INSTRUCTION TO SERVICE

ITS: 61038		March 4, 2025
SECTION:	549-Heating, Ventilation & AC	
WRITTEN BY:	New Flyer Service Engineering	
SUBJECT:	R&R Engine Sheave & Replace Belt	
ISSUE:	AC belt splitting into two pieces. The engine sheave doesn't have chamfered edges where the belt contacts the sheave.	
SUMMARY:	Remove and discard existing sheave and belt replace with new.

Figure 1: Chamfered Edges on New Engine Sheave

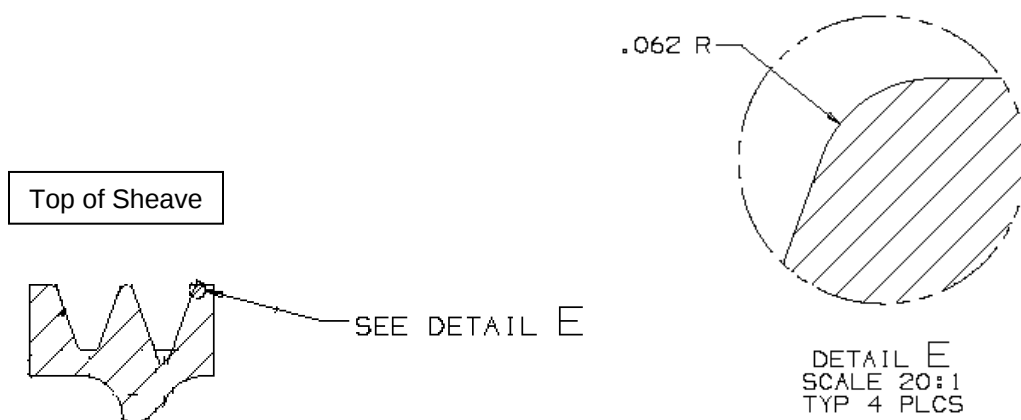
☞ **NOTE:** Ensure the new sheave (NF PN 601202_B) has chamfered edges as shown in Figure 1.

4. Install new engine sheave (NF PN 601202_B) using four new bolts (NF PN 883038). Torque to 80 – 85 Ft/Lbs dry. Add a torque mark. See Figure 2 & 3.

Figure 4: Belt Alignment

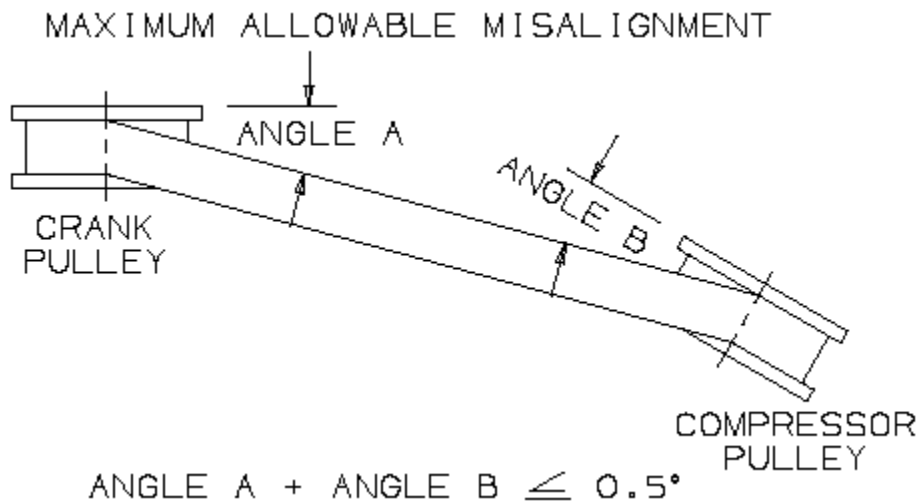
5. Install new belt (NF PN 862711) as shown in Figure 3. You will have to adjust the turnbuckle of the compressor plate in order to loosen/tighten the belt. Ensure belt is properly aligned as shown in Figure 4. Re-torque compressor plate nuts to 172 Ft/Lbs.
